# UNITED STATES PATENT AND TRADEMARK OFFICE

APPLICATION NO.	FILING DATE	FIRST NAMED INVENTOR	ATTORNEY DOCKET NO.	CONFIRMATION NO.
10/633,958	08/04/2003	Hye Suk Chi	RPS920030032US1/2805P	5183
47052 7590 01/23/2008 SAWYER LAW GROUP LLP PO BOX 51418 PALO ALTO, CA 94303			EXAMINER FERGUSON SAMRETH, MARISSA LIANA	
			ART UNIT 2854	PAPER NUMBER
			NOTIFICATION DATE 01/23/2008	DELIVERY MODE ELECTRONIC

## Office Action Summary

## **DETAILED ACTION**

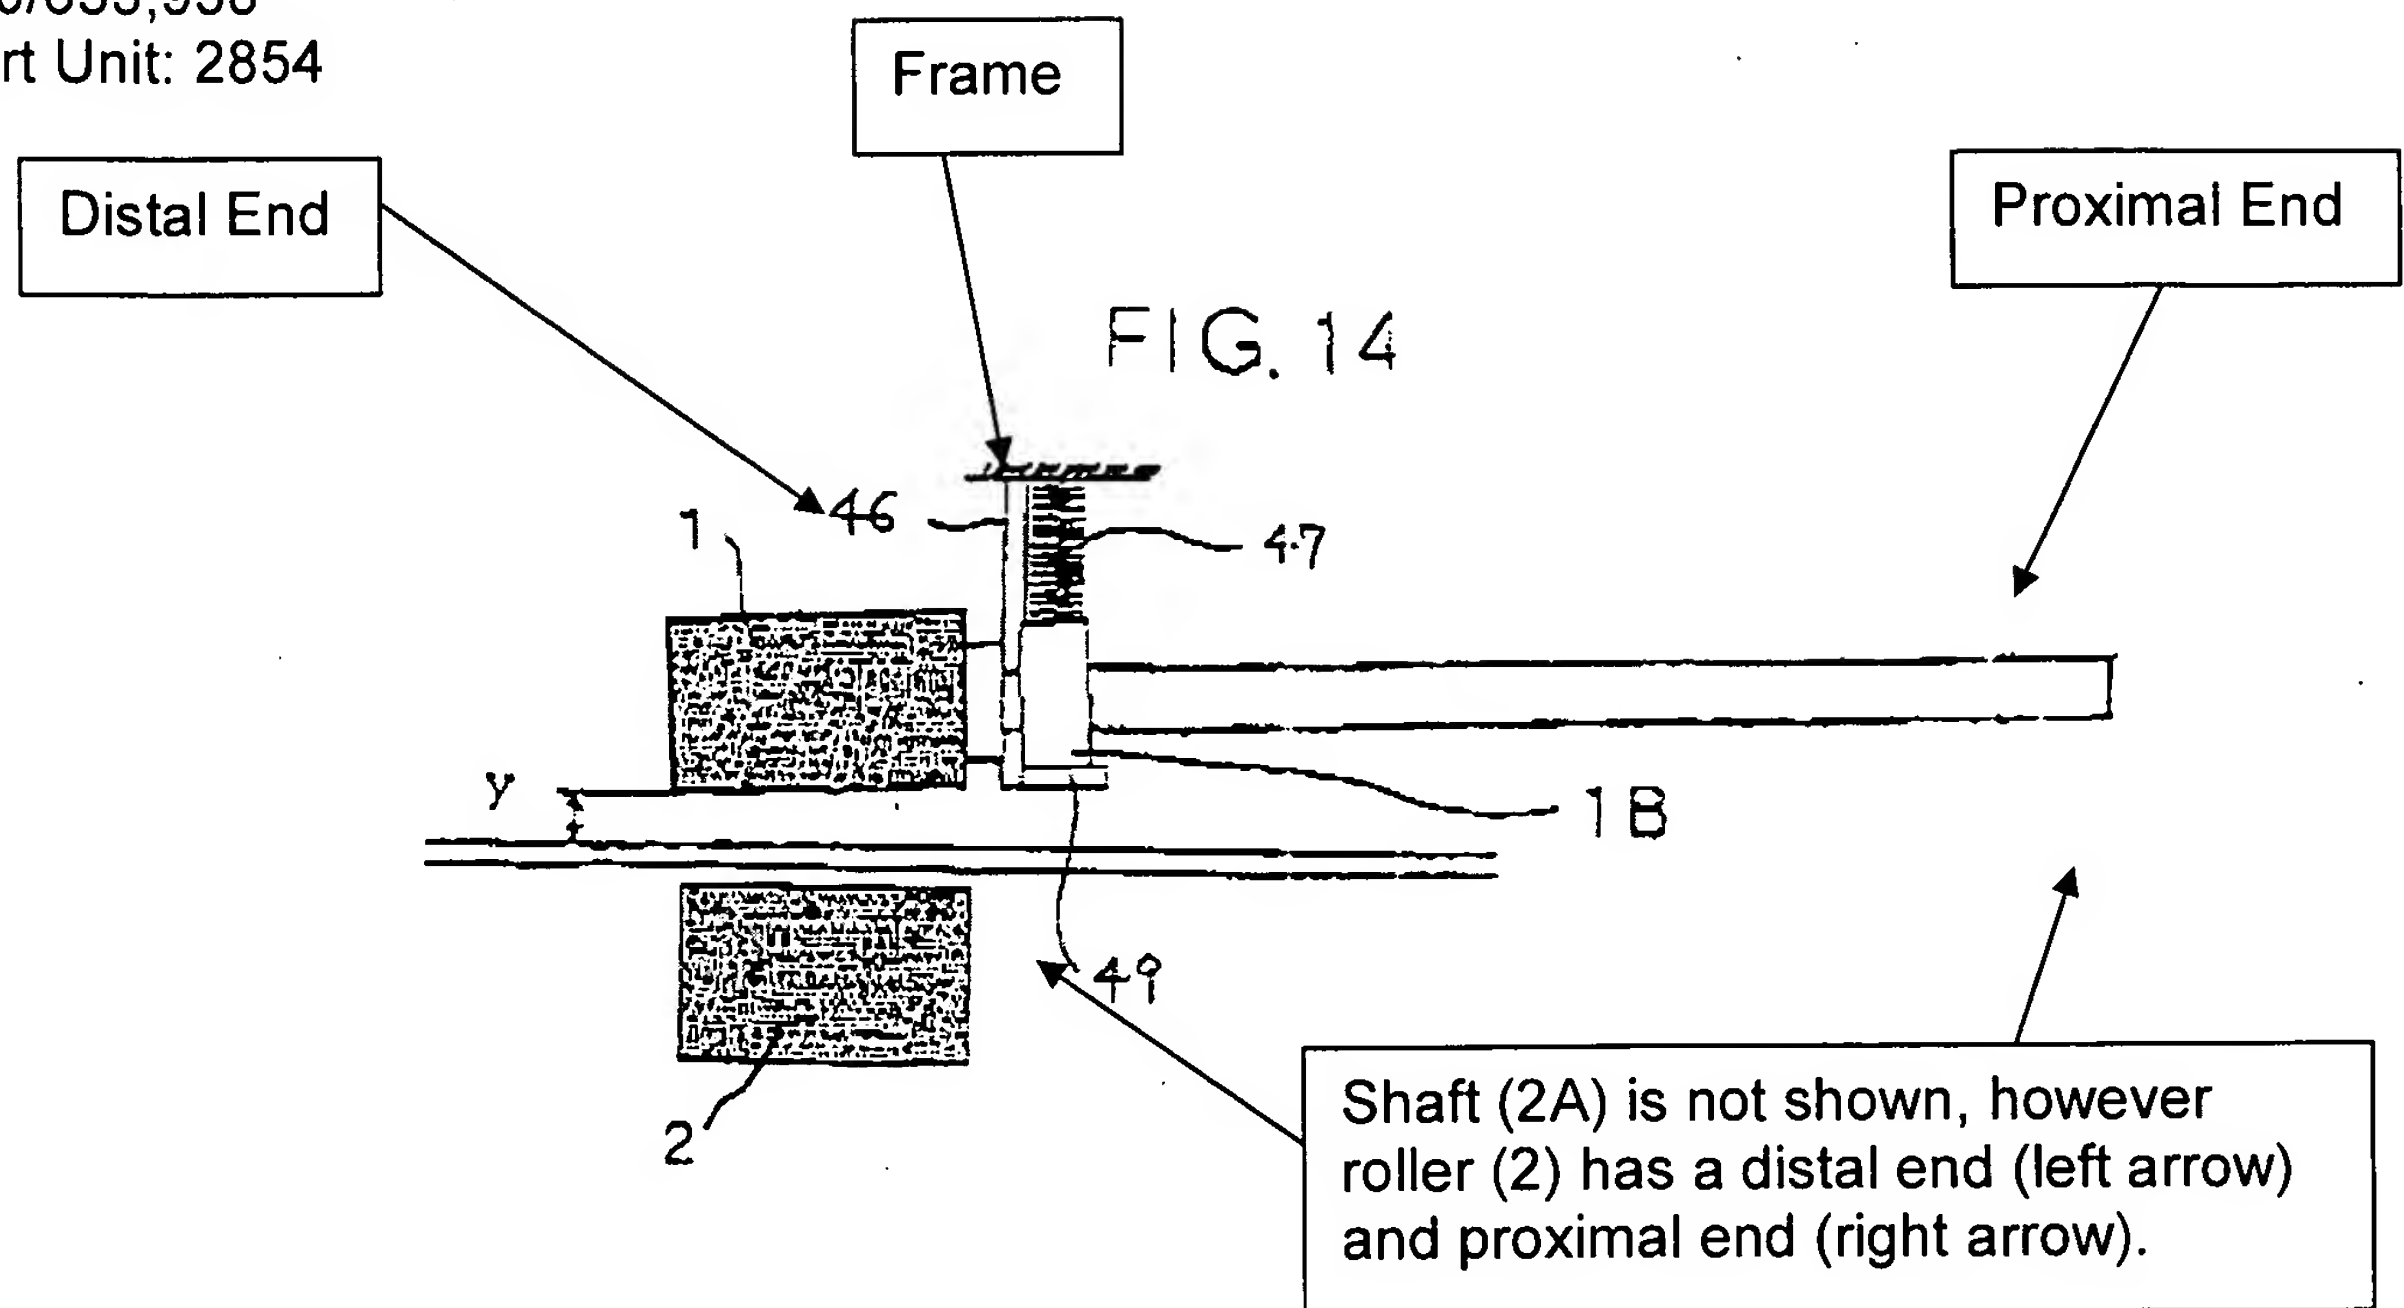
Regarding claims 1, 10, 20, 32, 40, 41, Miki teaches a method and apparatus comprising a frame (10), at least one cantilevered roller shaft (1A) comprises a distal end and a proximal end (refer to figure on page 4 of the detailed action) for advancing a document (P1,P2), wherein the proximal end is coupled to the frame of such that the distal end floats [As for advancing a document, wherein the at least one cantilevered roller shaft is supported only at one end (Figures 12-14)], a bearing (1B) coupled to the at least one cantilevered roller shaft (Figures 12-14) and a spring (47) coupled to the frame (10 and Figure on page 4 of the detailed action) and the bearing (1B) such that the at least one cantilevered roller shaft is spring loaded against a drive roller shaft.

Regarding claims 3, 11 and 21, Miki teaches wherein a need for a rigid frame that directly supports the unsupported end is eliminated (Figures 12-14).

Regarding claims 6, 7, 15, 16, 26, 27, 35-37, 43-45 Miki teaches a method and apparatus comprising a second roller shaft (2A) coupled to the frame (10), a second roller shaft (2A) with a proximal and distal end that is cantilevered wherein a second unsupported end of the second cantilevered roller shaft floats (Figure 14), inserting the document in a document path of the printer until the document reaches the at least roller and the least one second roller, rotating the two rollers (Column 2, Lines 8-44) and removing the document from the path (note: it is apparent that the document is removed).

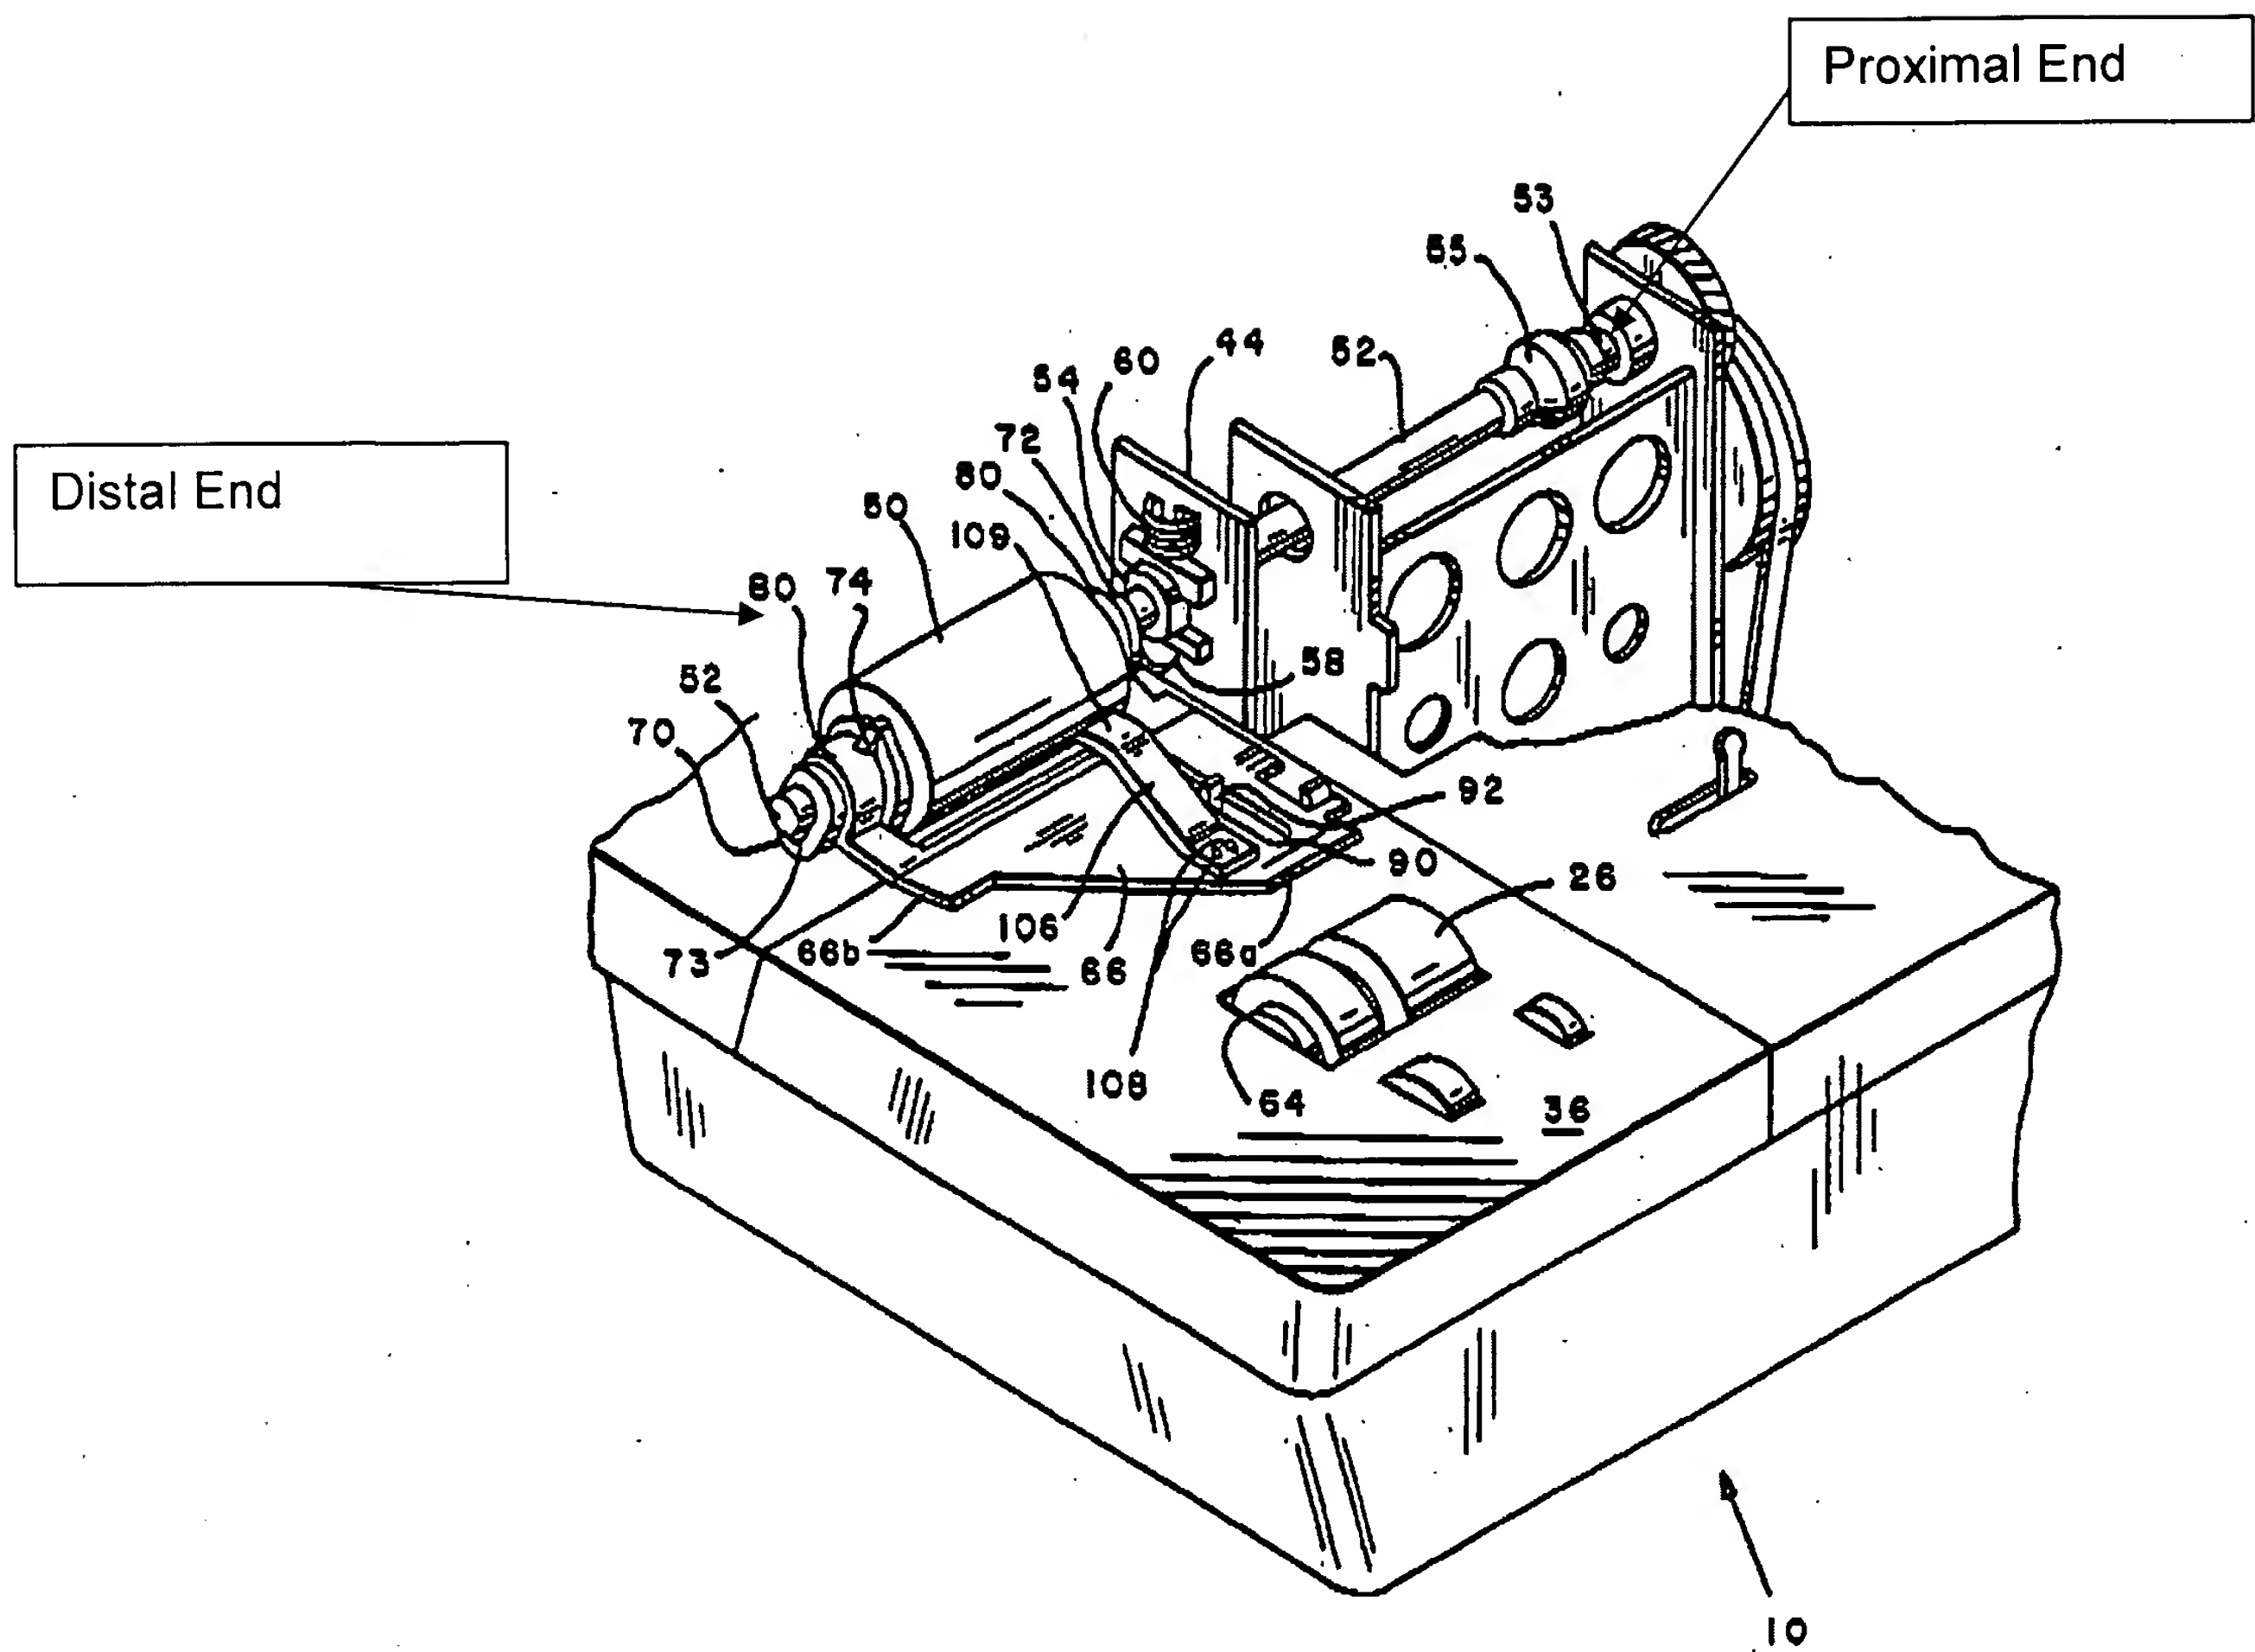
Regarding claims 1,10,20,32 and 40, Miciukiewicz teaches a method and apparatus comprising a frame (10, 12), at least one cantilevered roller shaft (52) comprises a distal end and a proximal end (refer to figure on page 3) for advancing a document (18), wherein the proximal end is coupled to the frame of such that the distal end floats, wherein the at least one cantilevered roller shaft is supported only at one end (Figure 2), a bushing/bushings (70, 72) coupled to the at least one cantilevered roller shaft and a spring (106) . However, he does not explicitly disclose a spring coupled to the frame and the bearing such that the at least one cantilevered roller shaft is spring loaded against a drive roller shaft. Miki teaches a spring (47) coupled to the frame (10 and Figure on page 4 of the detailed action) and the bearing (1B) such that the at least one cantilevered roller shaft is spring loaded against a drive roller shaft.

Regarding claim 2, 3, 11, 12, 21, 22, Miciukiewicz teaches a method and apparatus wherein a supported end of the at least one cantilevered roller shaft is supported at two support locations (44, 55) located outside a document path, wherein the document (18) can be appropriately fed and wherein the need for a rigid frame directly supports the unsupported end is eliminated (Figure 2).

Regarding claims 4, 13 and 23, Miciukiewicz teaches a method and apparatus comprising wherein the frame further comprises a main portion (12) and front portion (10), and wherein the at least one cantilevered roller shaft (52) is coupled to the main portion such that the at least one cantilevered roller shaft does not rely on the front portion for support.

Regarding claims 5, 14 and 24, Miciukiewicz teaches a method and apparatus comprising wherein at least one gimbal roller (50) is coupled to the at least one cantilevered roller shaft (52).

**FIG. 1**

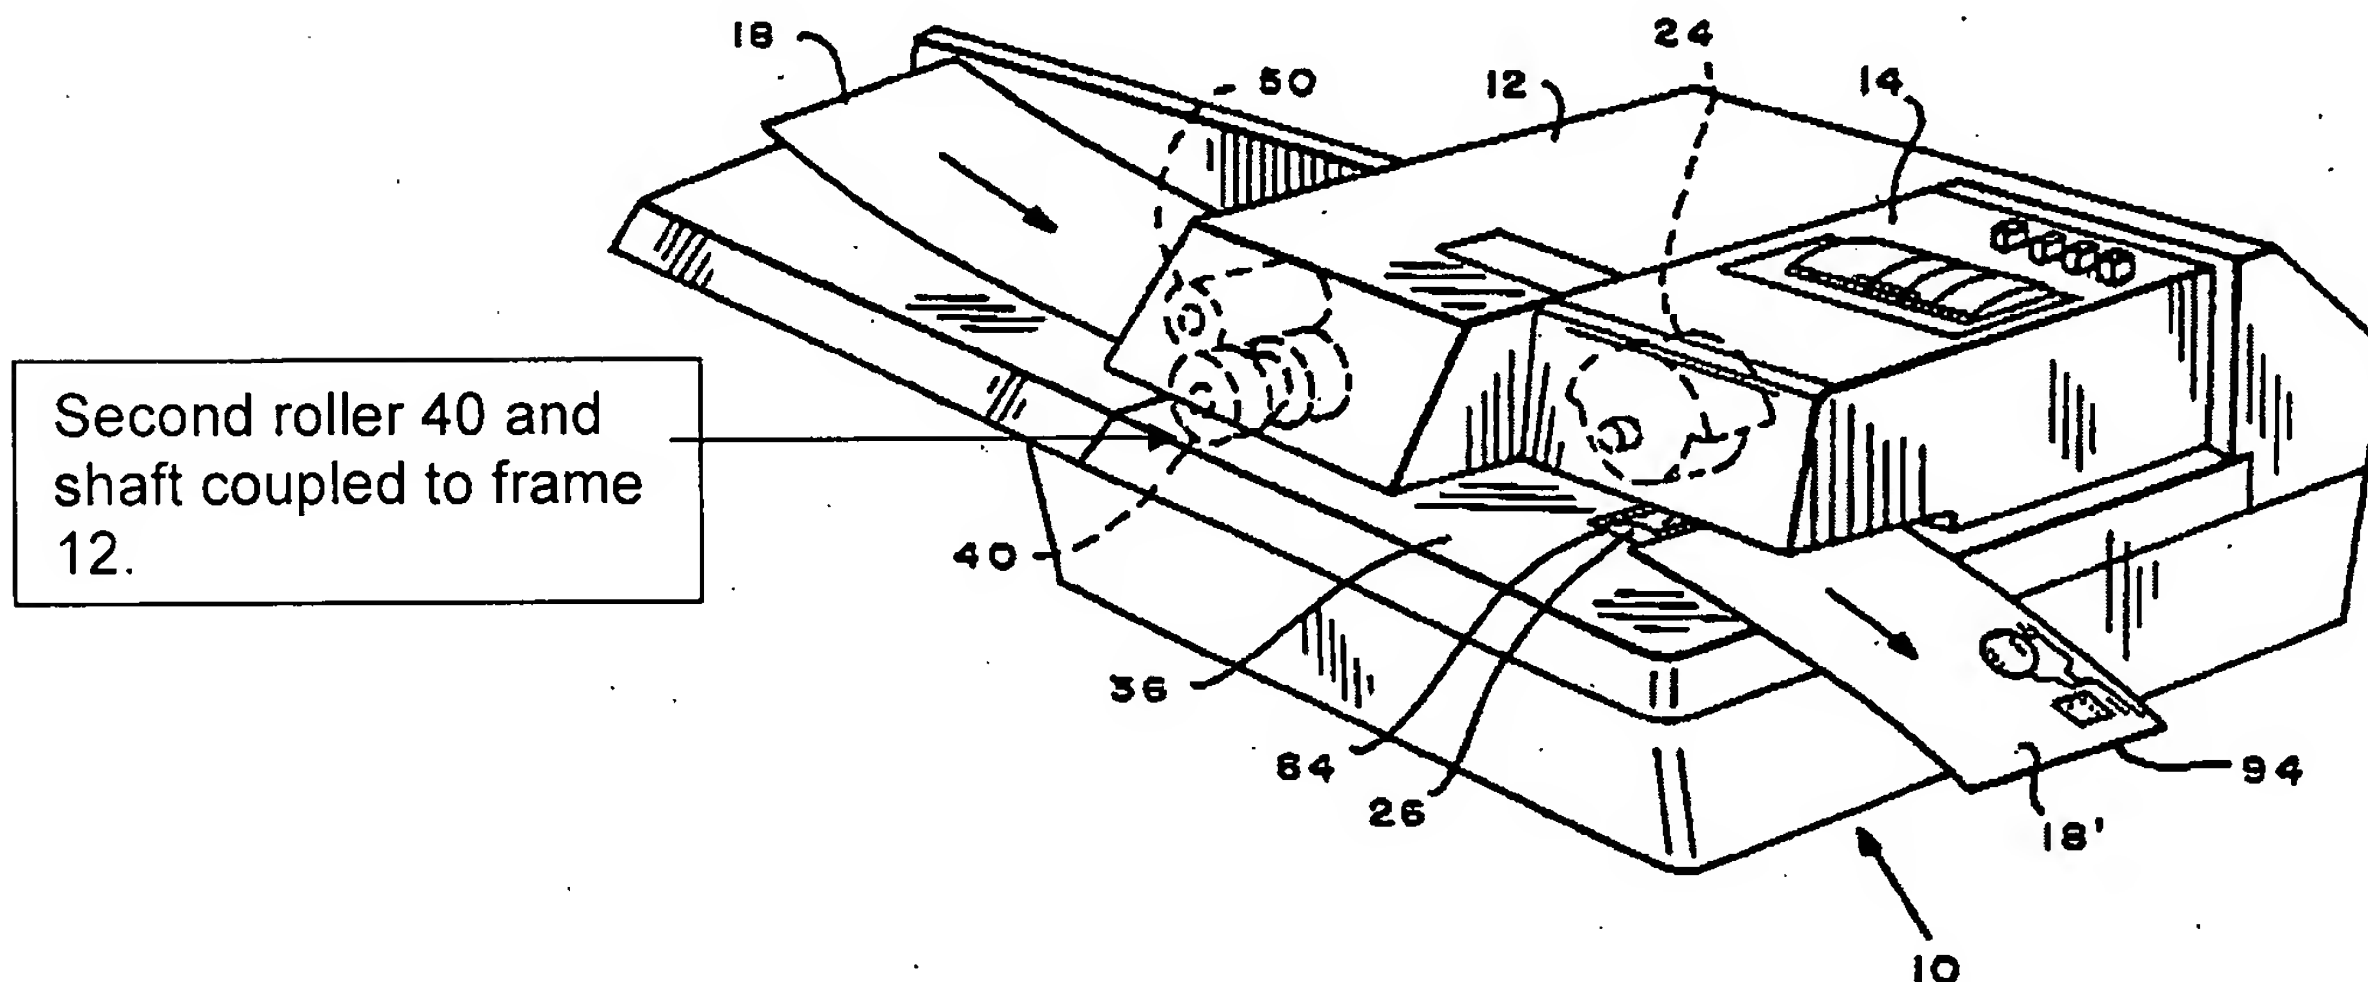
Regarding claim 15, 26, 35, 36,37 and 43, Miciukiewicz teaches a method and apparatus comprising, a second roller shaft coupled to the frame (refer to figure 4 on page 5 and figure 1 below) for advancing a document, a second roller shaft having a distal and proximal end (refer to figure 8 on page 5), wherein the distal end floats and wherein the document is removed from the path (note: this is an obvious feature).

Regarding claims 18, 29, 44 and 45, Miciukiewicz teaches a method and apparatus comprising wherein the frame further comprises a main portion (12) and front portion (10), and wherein the second roller shaft (refer to figure 1 on page 4 and figure 4 on page 5) is coupled to the main portion such that the second roller shaft does not rely on the front portion for support.
